## PARRAMATTA EAST PUBLIC SCHOOL UPGRADE –

### BUILDING CODE OF AUSTRALIA REPORT

**PARRAMATTA EAST PUBLIC SCHOOL  
30-32 BRABYN STREET NORTH PARRAMATTA, NSW 2150**

Report Ref: 24-222129 SINSW\_100%ParramattaEast\_BCAREportR06\_20250226

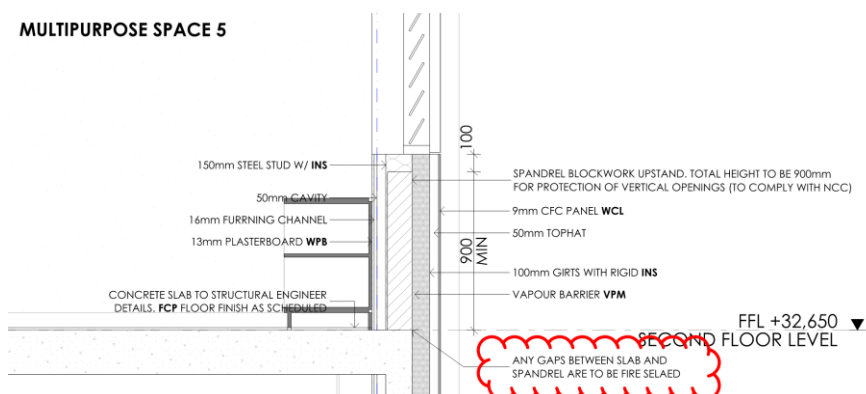
***The design of the 'R Block' includes adequate measurements for spandrel protection to ensure vertical separation of openings are achievable. The north and west elevation drawings specify spandrels with a minimum height of 900mm, extending at least 600mm above the upper surface of the intervening floor. This requirement does not apply to the south elevation openings due to the extended concrete slab walkway projecting more than 1100mm from the external face of the wall. The Eastern Elevation to 'R Block' does not require spandrel protection.***

**Further review of the external wall section drawings also shows that any gaps between the slab and spandrel are to be fire sealed in accordance with Clause C4D16. In addition, please note that any supporting elements must be appropriately treated to ensure the Spandrel FRL is maintained,**

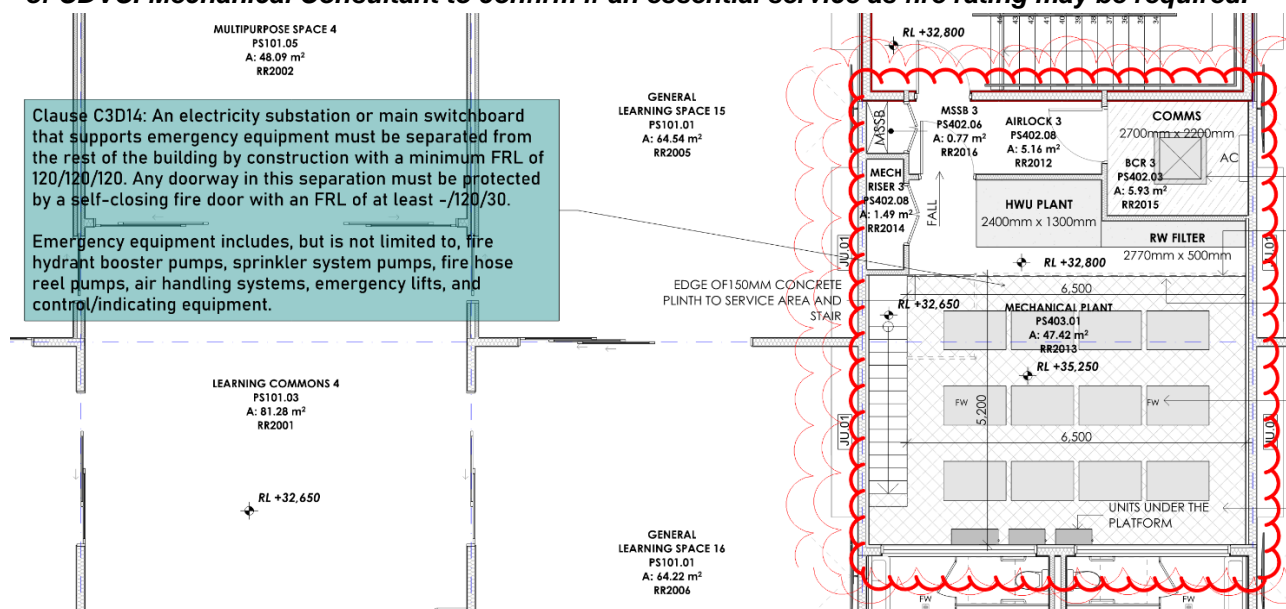
9. **Separation of equipment (C3D13)** – Equipment comprising of lift motors, lift control panels, emergency generators, central smoke control plant, boilers or any battery or batteries installed in the building that have a voltage of 12 volts or more and a storage capacity of 200kWh or more must be constructed with an FRL in accordance with Tables S5C21a - S5C21g of Specification 5 in the BCA but not less than 120/120/120.

**Architect to note, details to be provided prior to the issue of CDVC.**

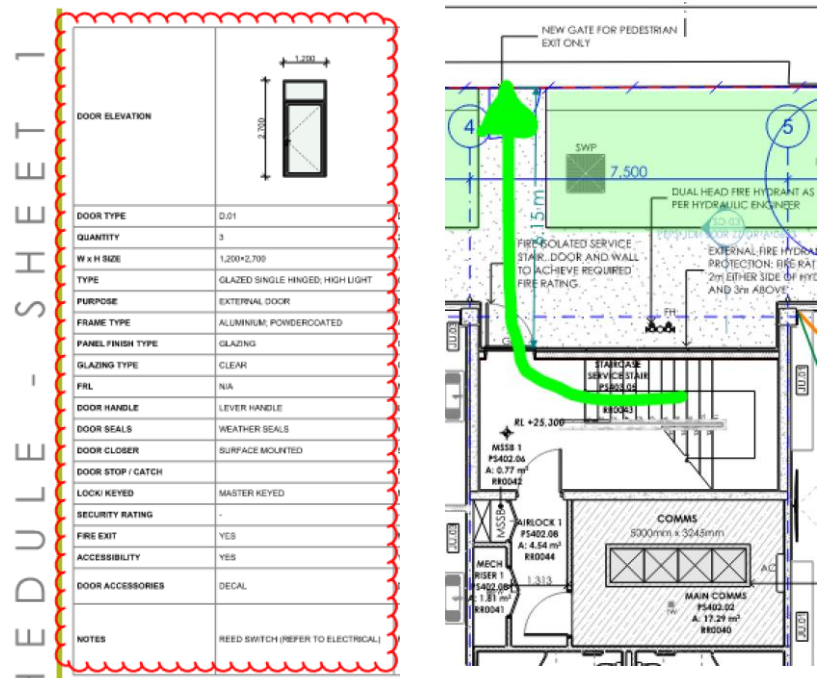
***The 'R Block' includes a fire-isolated stair shaft discharging at ground level along a proposed***

pathway on the Northern Boundary. The external walls of the fire exit are located within 6m and requires an FRL as the path of travel from the point of discharge necessitates passing within 6m of any part of the external wall.

*Please note the inconsistency between the door schedule and plans, with the plans advising a fire isolated service stair door and wall to achieve the required FRL, whereas the door schedule depicts a glazed external door.*

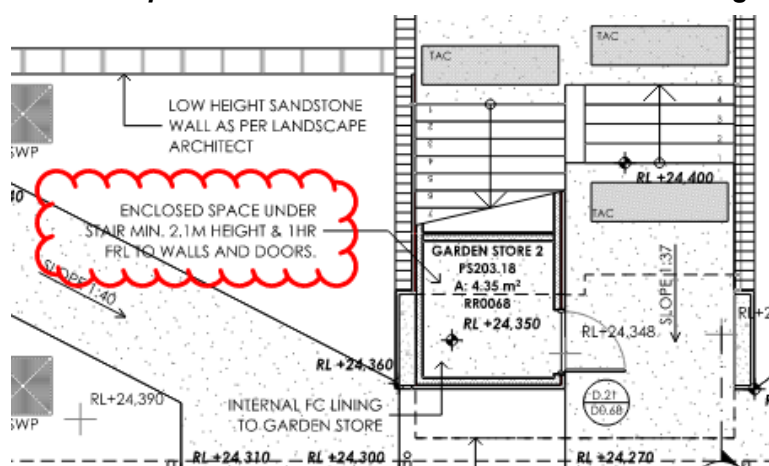
***The plans show enclosed spaces beneath external stairs 1, 2, and 3. The enclosing walls and ceilings must achieve an FRL of at least 60/60/60. Plans provided are annotated to demonstrate the proposed enclosed spaces will achieve a minimum 1-hour fire rating to walls and a 1 hr rating to the fire door.***

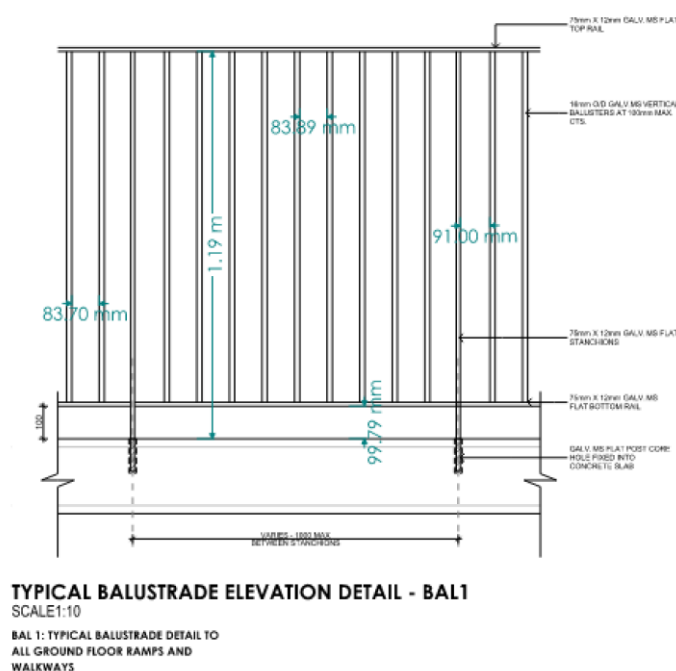
***The design of the external stairways features a barrier-like screen to prevent falls. Detailed drawings and structural design certificate to be provided prior to the issue of CDVC.***

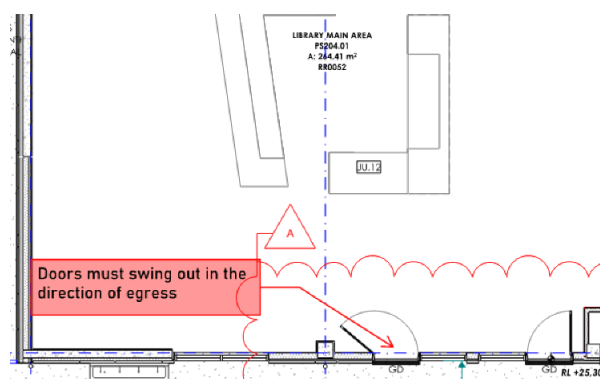
**The swinging doors to the R Block Library/Main area does not swing out in the direction of egress to the southern external walkway. All other swinging doors throughout Block R are shown to comply the requirements of this clause.**
